TECHNICAL SERVICE BULLETIN

REF.: HEATING & AIR
CONDITIONING
NO.: AC95-002
DATE: JUNE 16, 1995
MODEL: AE

HEATER CONTROL KNOB RETENTION IMPROVEMENT

ILLUSTRATION:

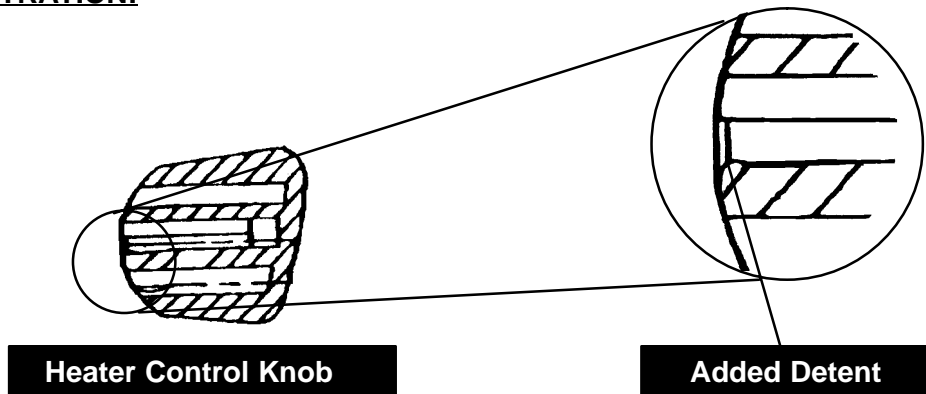
To improve retention of the Heater Control Knobs on North American built Corollas, a production change has been made. The inner dimension of the knob has been modified to provide an audible "click" when installed properly.
